14 September 2026

Response to Further Advice Request and Notice of Minor Changes in relation to Development Application at Toowong Central (Council Ref.: A006836692)

2 Response to Further Advice

Figure 1 – Extract of Revised Site Elevation – North

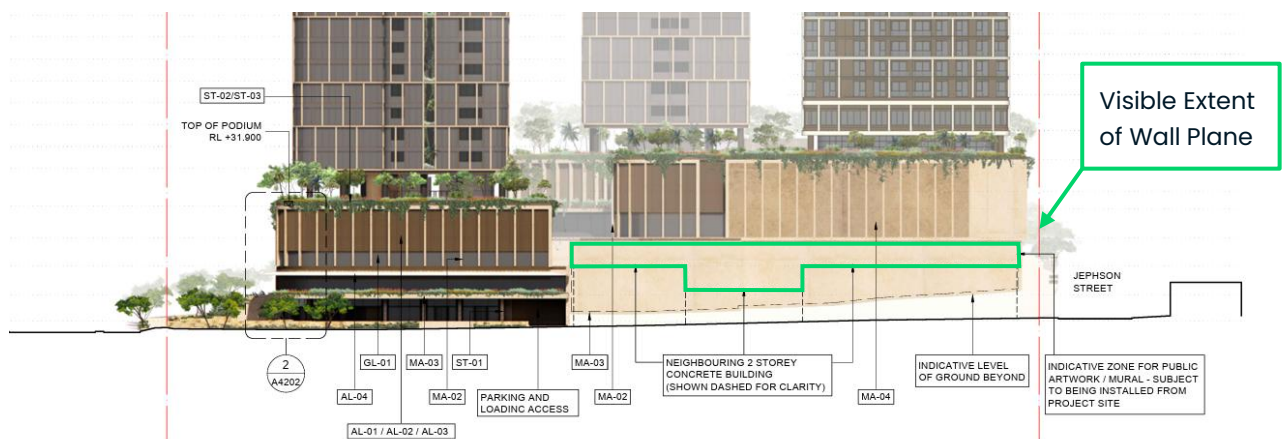
It is acknowledged that the proposed podium height has been reduced within five storeys in some parts of the site. This is apparent where located at the side boundaries of the adjacent sites at the corner of Jephson Street and Sherwood Road. However, some podium walls would benefit from greater variation in the wall plane, as they will remain visible from nearby streets and may still present with a bulky appearance.

- Demonstrate the use of design elements (architectural form, colour, texture, materiality and detail) to avoid a bulky appearance. It is acknowledged that the elevations show some variation in the appearance of this wall interface, however, it is not apparent that the proposed finishes are sufficient to reduce the bulk.*
- To ensure the podium forms are sufficiently broken down in scale and adequately activate streets and arcades, further clarification is required through the provision of higher scale elevations and part sections for active frontages.*

In response to **Item 1**, the Applicant has amended the Architectural Drawings to include additional detail on the design elements and finish treatments proposed at the corner of Jephson Street and Sherwood Road. To further support Council's assessment of the podium design, additional drawings illustrating higher scale elevations and sections for active frontages are provided within **Appendix B – Revised Architectural Drawings**.

At the outset, it is noted that the elevation identified by Council does not reflect a realistic representation of the proposed development when viewed from the public realm at Sherwood Street. Having regard to the existing commercial tenancies fronting Sherwood Road, the extent of wall plane visible from Sherwood Road is understood to be limited to the areas outlined in **green** in **Figure 1** below.

Nonetheless, to provide additional visual interest and reduce the perception of bulk, the Applicant and its project team have identified an opportunity to incorporate a combination of artwork and colour finishes to the visible blank wall planes identified above.

Figure 2 – Equitable Access Plans

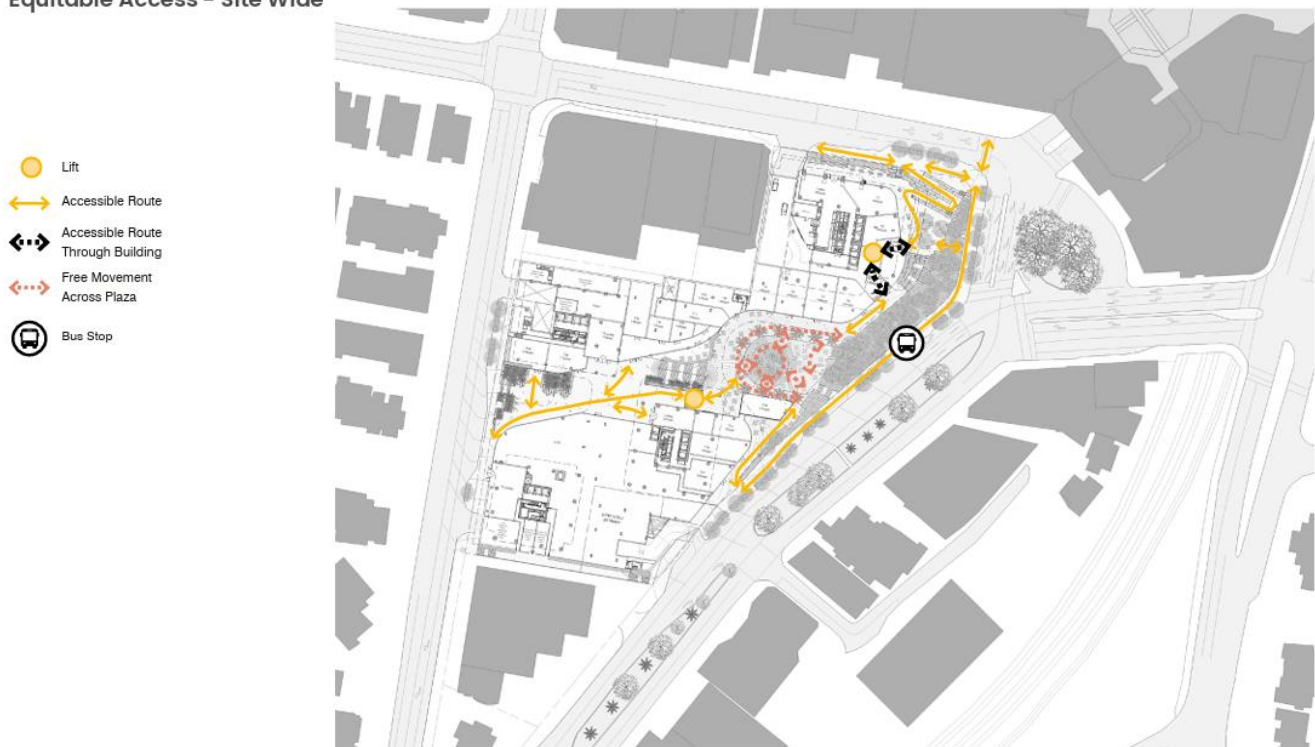
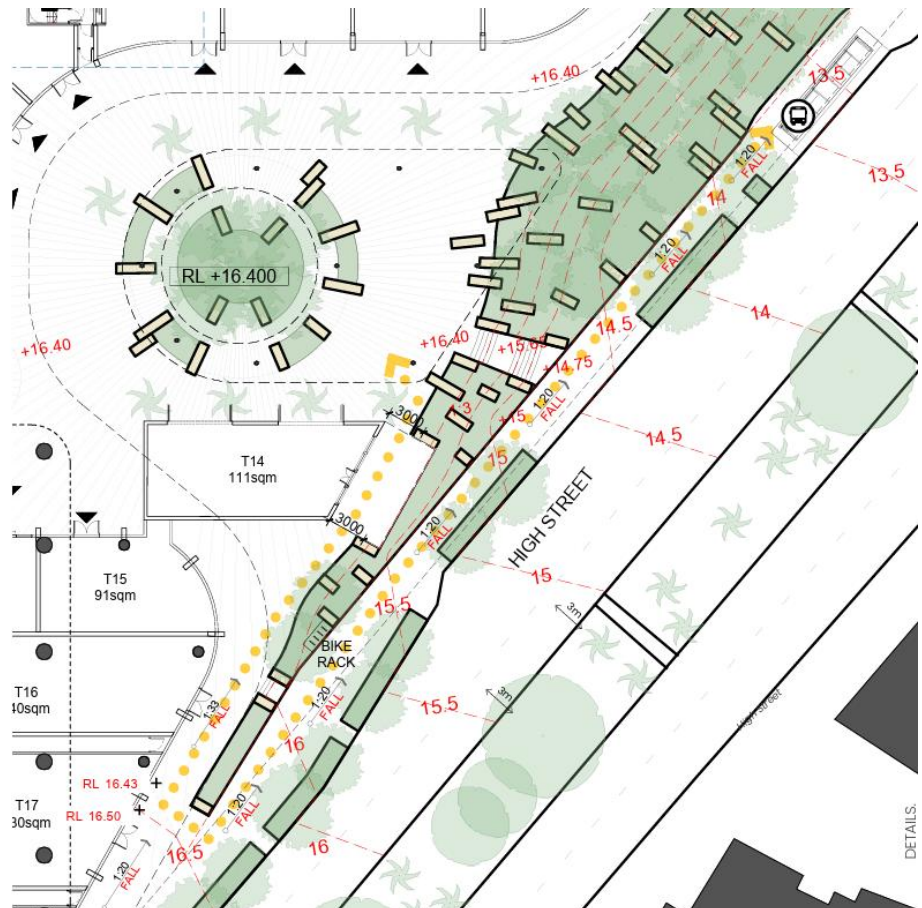
Some further clarification is required with regard to pedestrian movement from the relocated indented bus stop on High Street to the plaza levels and in particular, demonstrating equitable access to the plaza levels. It appears that there is a significant level change between the bus set down area and the plaza level without any direct means of equitable access.

In response to **Item 2** of Council's Further Advice Request, *Urbis Ltd* has prepared equitable access plans at two scales as shown in **Figure 2**. This includes a site-wide plan and a more detailed plan demonstrating equitable access between the bus set down area and Central Plaza.

Figure 3 – Tower 3 Level 4 Plan Extract

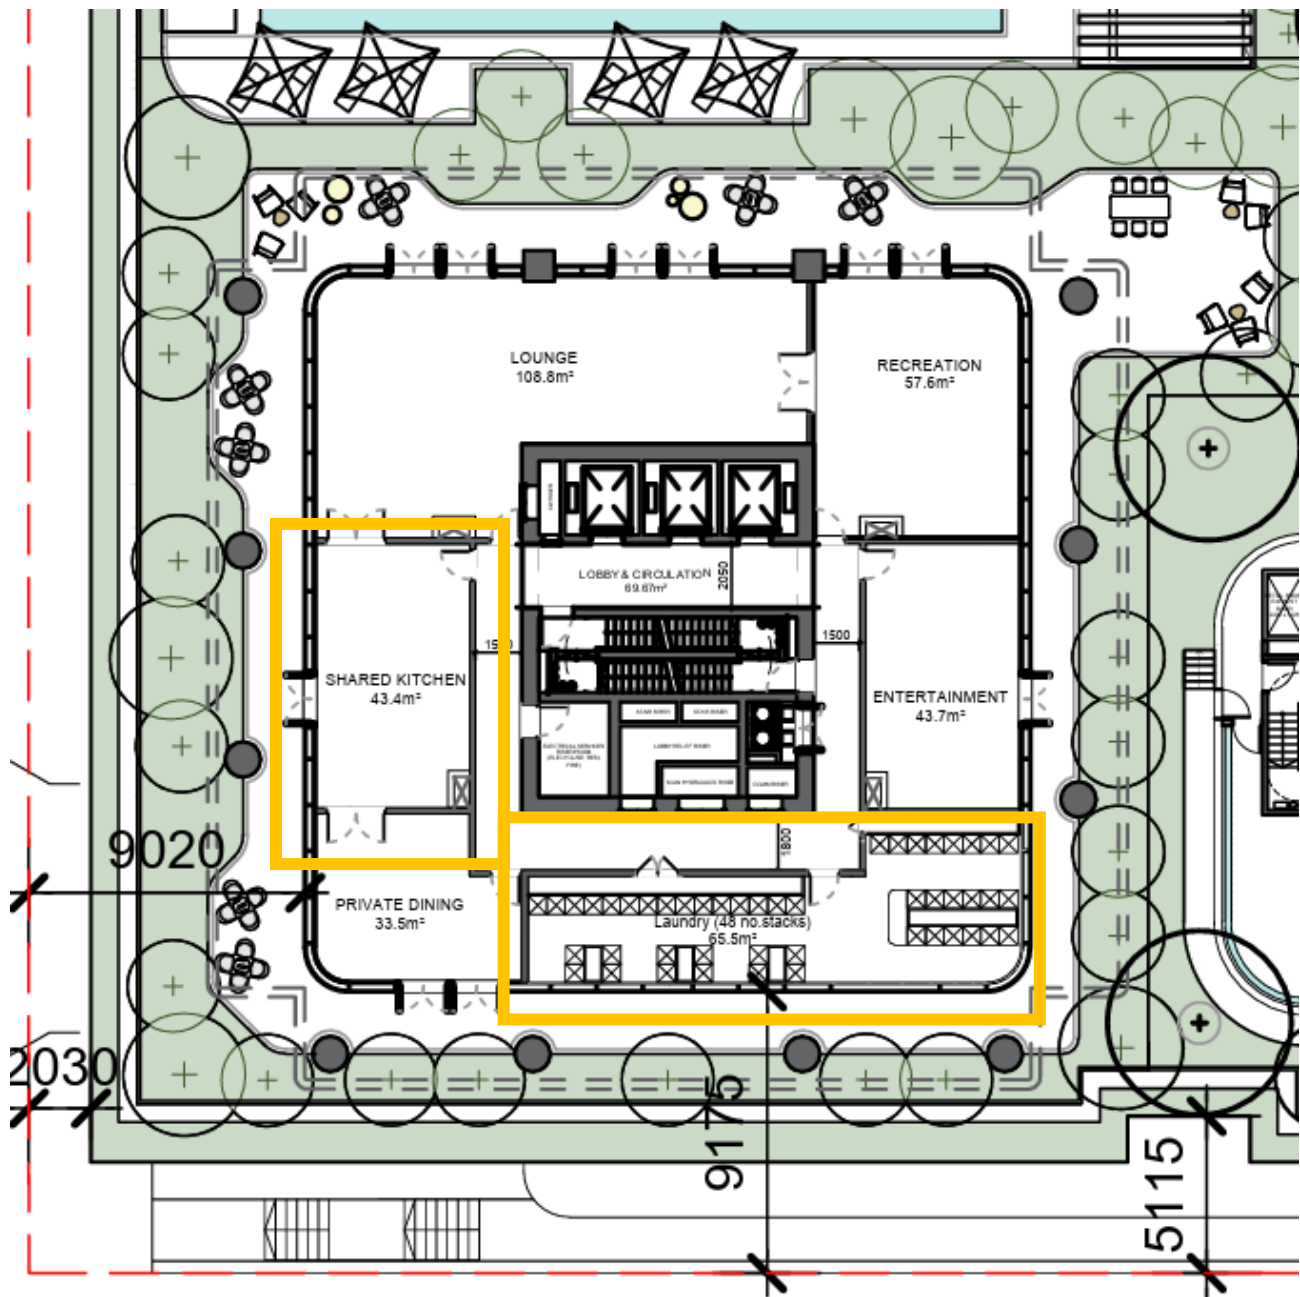
- a. *Provide a breakdown of the spatial allocation for kitchen and laundry facilities along with the total number of residents intended to occupy the building.*
- b. *Provide additional common kitchen and laundry facilities at other levels throughout the height of tower.*
- c. *Nominate the location for Short term accommodation management offices and mailrooms.*

In response to **Item 3(a)** and **Item 3(b)**, the architectural plans have been updated to provide additional detail on the proposed rooming accommodation within Tower 3. The amended plans (as shown in **Figure 3**) confirm that Tower 3 has been designed to accommodate a total of 702 residents and that each studio and two-bedroom unit is provided with an internal kitchenette appropriate to the intended occupancy of the unit.

As outlined in **Table 1**, the proposed kitchen and laundry facilities have been assessed against the relevant requirements of *QDC MP 5.7 – Residential Services Building Standard*. The amended plans demonstrate that the proposed arrangements provide appropriate facilities to support the health, safety and amenity of residents, having regard to the purpose-built student accommodation typology and the combination of private in-room facilities and shared communal facilities available within the building.

Figure 5 – Mail Rooms and Lockers

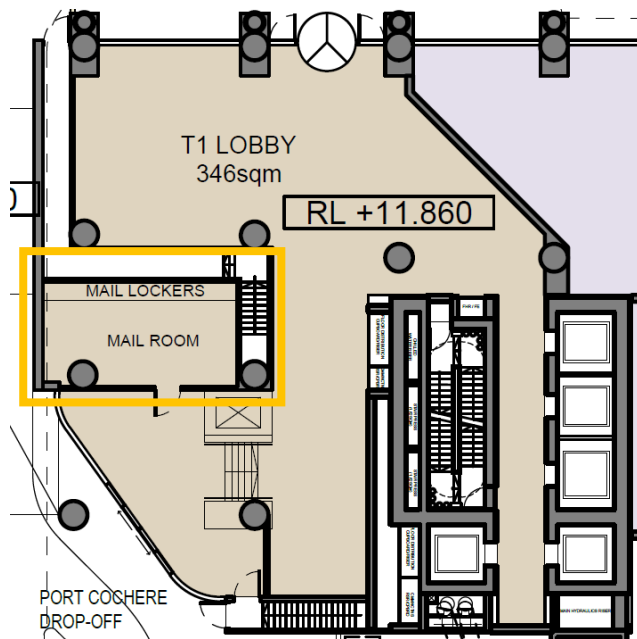
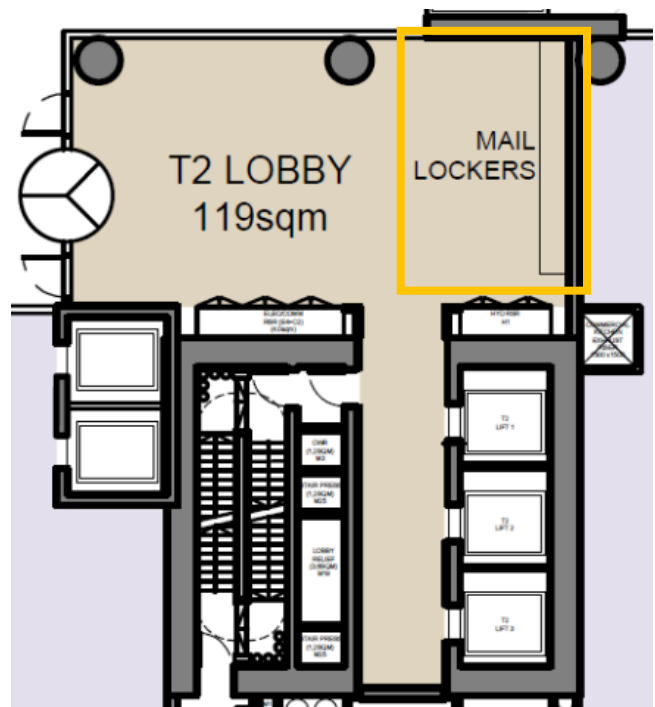
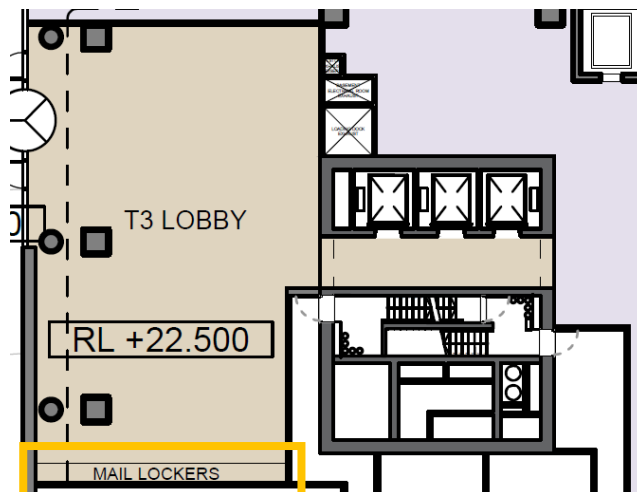
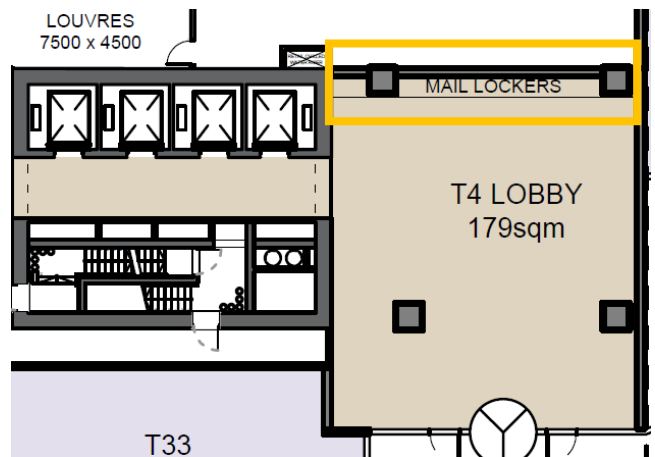
- a. Demonstrate that the development will design for crime prevention.*
- b. Provide mail/parcel deliver spaces for all residential towers.*
- c. Provide management spaces for each residential tower aligned with ground level lobby spaces.*

In response to **Item 4**, dedicated mail rooms and lockers are provided within the lobby spaces of each Tower, as illustrated in **Figure 5** below and in **Appendix B – Revised Architectural Drawings**.

It is noted that the proposed mail room and locker facilities are located within the residential lobby areas, which are access-controlled and available only to residents and authorised persons. The facilities are therefore situated within a secure environment that restricts public access, providing arrangements that minimise opportunities for unauthorised entry, theft and vandalism.

Figure 9 – Equitable Access Plan
Equitable Access – Site Wide

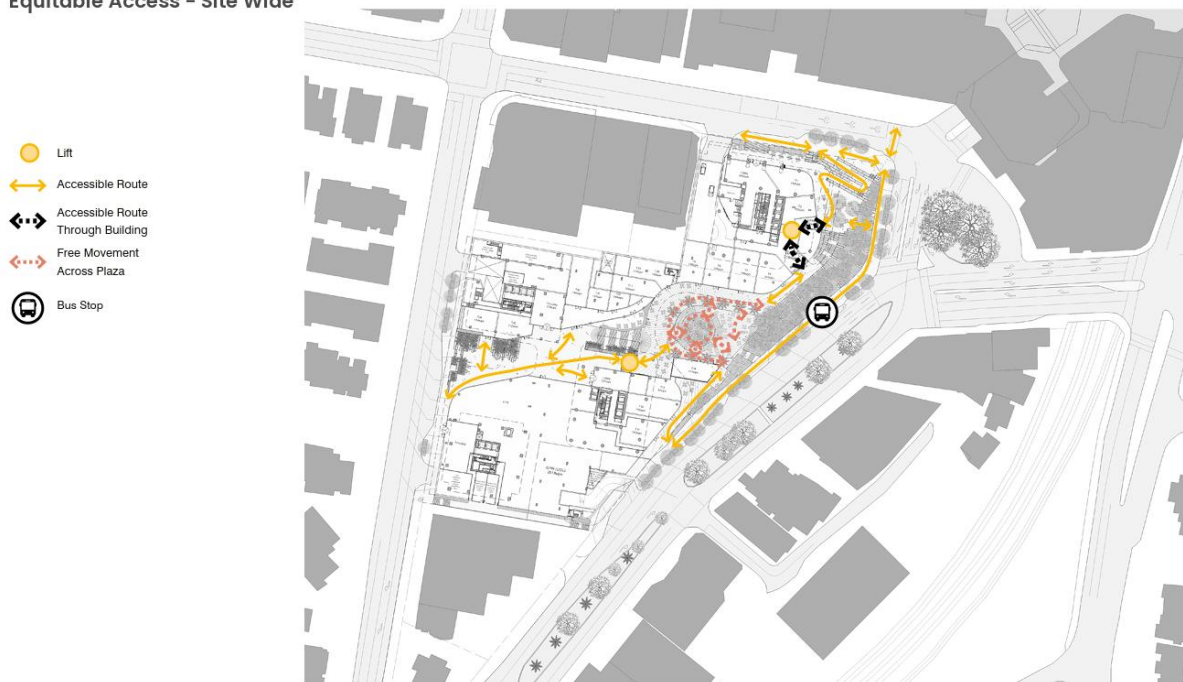
The proposed relocation of the heritage building creates unequitable access and circulation within the common plaza by introducing pedestrian and cyclist pinch points. The location of heritage building and pedestrians/cyclist flow from the public realm into the site should be reconsidered to provide access to the site that meets the requirements of PO7 and PO8 of the TAPS code.

As outlined in the response to Items 2 and 7, *Urbis Ltd* has prepared updated equitable access plans, included within **Appendix C – Revised Statement of Landscape Design Intent**. These plans comprise both a site-wide equitable access strategy and a detailed plan demonstrating accessible movement between the proposed bus set-down area and the Central Plaza.

In response to Council's concerns regarding pedestrian and cyclist pinch points associated with the relocated heritage building, the landscape design along High Street has undergone targeted revisions to

improve circulation and accessibility outcomes. The revised design maintains a continuous 3-metre-wide accessible pathway between the proposed bus stop and the plaza. The revised arrangement modifies the terrace area adjoining the heritage building to remove pinch points within the pedestrian network.

Bike racks have been strategically located at key activity nodes, including the Central Plaza, to support convenient and legible cyclist access throughout the site. As demonstrated within the equitable access plans at **Figure 9** and **Appendix C**, bicycle parking is positioned adjacent to accessible movement corridors, supporting safe and efficient integration of active transport infrastructure into the public realm.

Figure 10 – Lower Ground Bin Room

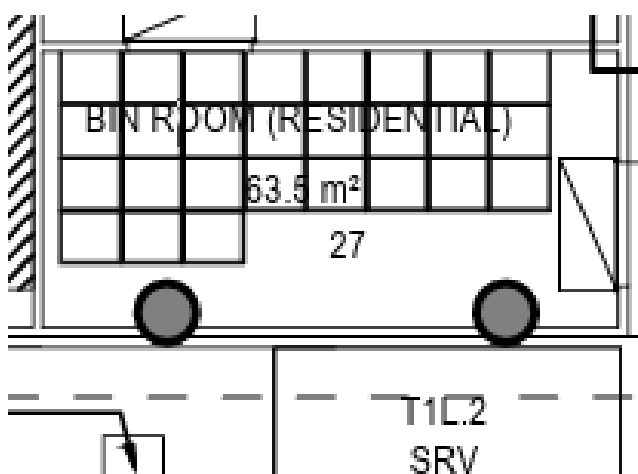
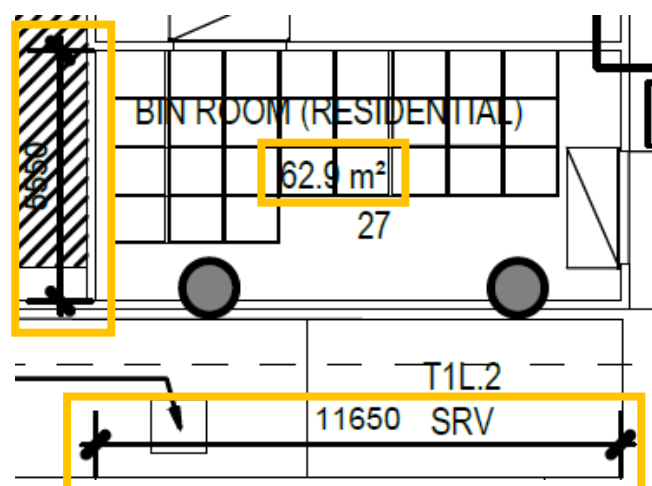
Provide amended architectural plans which clearly demonstrates the area (m^2) and internal dimensions of the Lower Ground 'Bin Room (Residential)'.

In response to **Item 18**, the architectural plans have been amended to accurately capture and annotate the relevant GFA (m²) associated with the Lower Ground 'Bin Room (Residential)', illustrated in **Figure 10** below.

Figure 11 – Ground Floor 'Bins Residential (T2 & T4)'

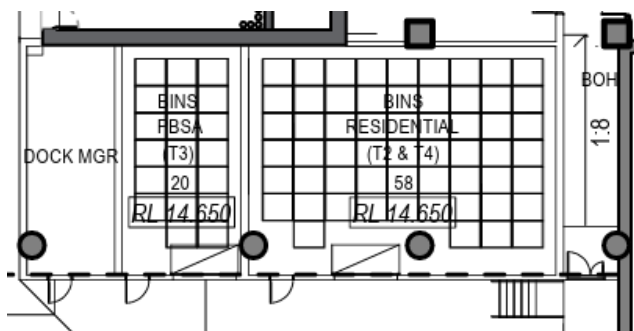
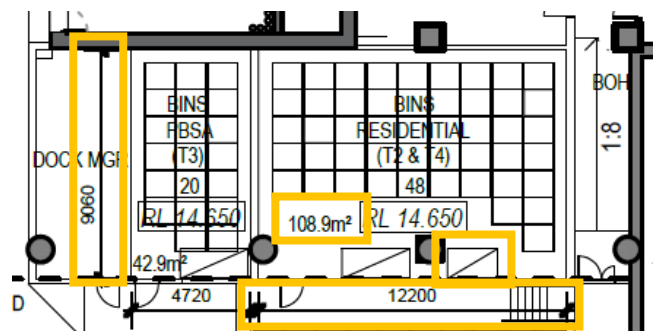
Additionally, provide a secondary roller door to the east of the proposed roller door to enable functional manoeuvring of bins. This is required due to the location of the structural supporting columns, which restrict bin movements within the bin room.

In response to **Item 20**, the architectural plans have been amended to introduce a secondary roller door (see **Figure 11**) to improve access to the bin room and facilitate easier movement and servicing of bins around the internal structural columns.

Figure 12 – Annotated Non-Residential Bin Collection

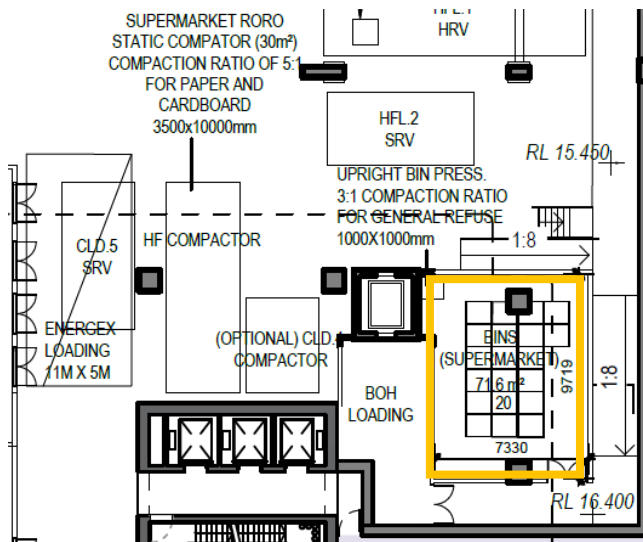
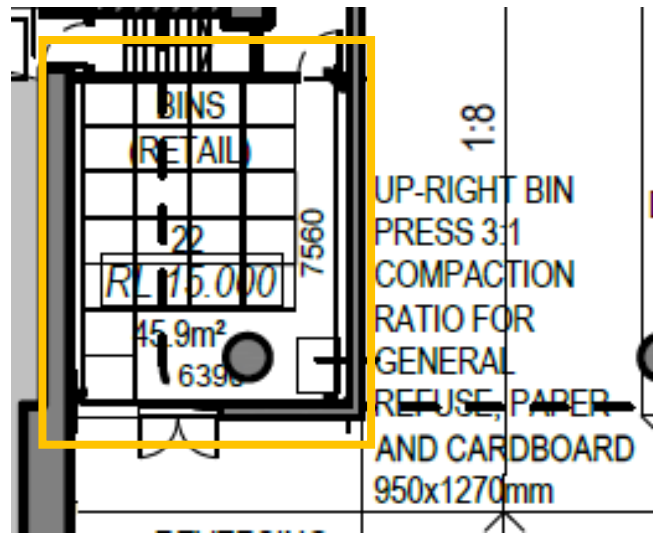
Provide amended plans annotating the area (m²) and internal dimensions on the architectural plans.

A series of administrative annotations are made to the Architectural Drawings (refer to **Appendix B – Revised Architectural Drawings**) in response to **Item 22** of Council’s Further Advice Request. This includes the inclusion of area (m²) and dimensions of non-residential bin collection areas, as illustrated in **Figure 12** below.
